28 Fitzroy Square, W1T 6DD

Full planning and listed building consent applications - 2018/1361/P & 2018/1481/L

Delegated Report (Members Briefing)		Analysis sheet	Expiry Date:	11/05/2018
		N/A / attached	Consultation Expiry Date:	19/04/2018
Officer			Application Number(s)	
John Diver			i) 2018/1361/P ii) 2018/1481/L	
Application Address			Drawing Numbers	
28 Fitzroy Square London W1T 6DD			See draft decisions	
PO 3/4	Area Team Signature	C&UD	Authorised Officer Signature	
		Charlie Rose (Principle Officer)		
Proposals				
<p>i) Rear extensions at ground floor level including roof terrace and new access door above following the demolition of first floor rear projection. Refurbishments to building incl. lowering of floor to front vault and installation of new AC plant all in association with the continued use of the building as an office (B1a)</p> <p>ii) External alterations to GII* listed property including ground floor rear extension and replacement window, demolition of existing first floor rear projection and provision of rear terrace (incl. access door and plant enclosure). Internal alterations incl. lowering of levels to front lightwell and refurbishments from basement to third

3.- 5. Existing rear extension / rear lightwell (area of infill highlighted in green and demolition in red)

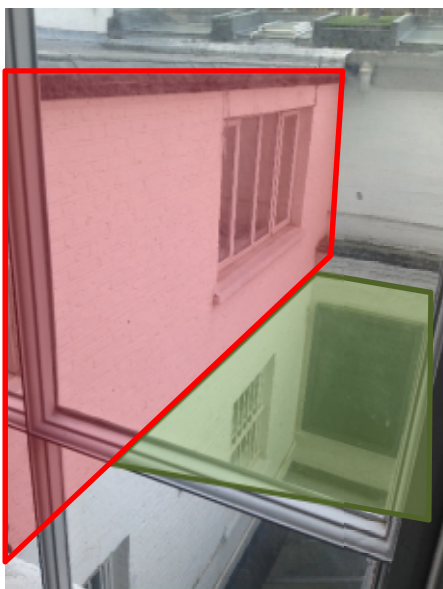
- 5.3. In terms of natural light and outlook, the proposed ground floor extension would infill an area of the rear lightwell which is already surrounded by built form (see photos 3-5). The retained area of rear light well at GF level would match the depth of that at no.27 exactly, and the height of the proposed infill extension would remain below the parapet level to all shared boundaries (both sides and rear). Given this full enclosed existing context, the proposed extension would not result in any loss of natural light or outlook to the detriment of any adjoining occupier. The perceived sense of enclosure would also not be increased to neighbouring properties by virtue of the existing surrounding built form. Due to the siting of the proposed GF rooflights in relation to surrounding built form, these glazed elements would not result in any harmful light pollution to surrounding residents.

15.-17. Typical modern interventions (e.g. fire doors, lighting, windows, flooring)

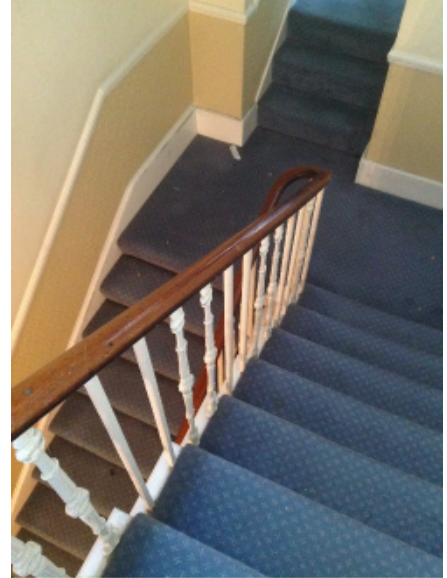
4.17. The proposal would include the lowering of the existing floor level of the front vault by 500mm in order to bring this room into use. Such works have been previously allowed to properties within the terrace and during the site visits, it was noted that the floor to this area was modern (see photo 17). The existing vault's height is not considered to be key in the properties significance and as such conservation officers did not raise concern in relation to the removal of the modern floor and its replacement at a lower level. As discussed later in the report, the application was supported by a basement impact screening report which did not identify any risk of structural movement to the host building or neighbouring sites. Given that the vault area is separated from the main building by a lightwell of 2.5m depth, these internal works are not considered to result in harm to the significance of the host building. Given that the use of the vault would require damp proofing to be installed, a condition is recommended for the submission of details of a physical barrier system (newton 500 or similar) to ensure that the historic stone work would not be harmed by this element.
